POLICY REPORT  
DEVELOPMENT AND BUILDING

Report Date: January 6, 2015  
Contact: Susan Haid  
Contact No.: 604.871.6431  
RTS No.: 10759  
VanRIMS No.: 08-2000-20  
Meeting Date: January 20, 2015

TO: Vancouver City Council  
FROM: General Manager of Planning and Development Services  
SUBJECT: CD-1 Rezoning: 6070-6090 Oak Street

Site / Landscape Plan

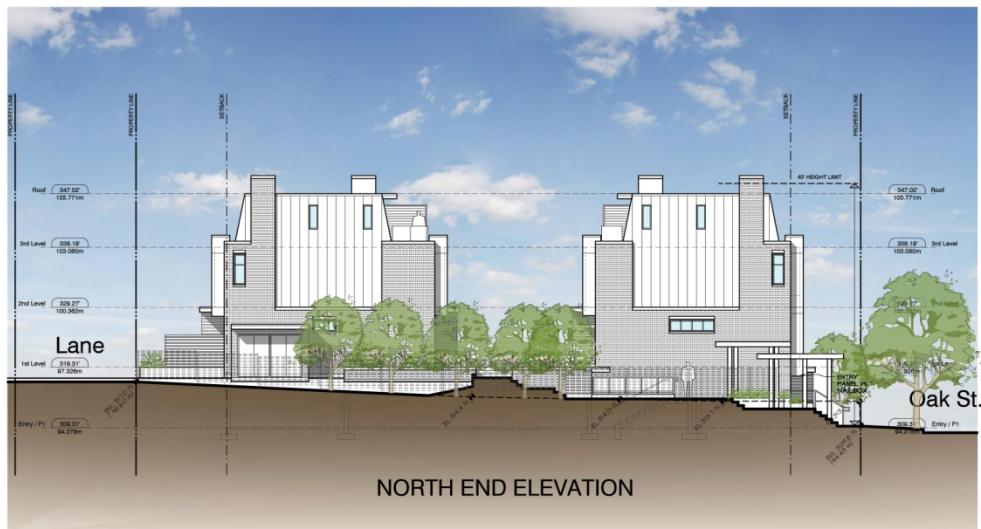
13. Relocate the metal fence, shown over the west property lines on pages SK.01.03 and L2, which is to be inside the property line.
14. Compliance with the Parking and Loading Design Supplement to the satisfaction of the General Manager of Engineering Services.
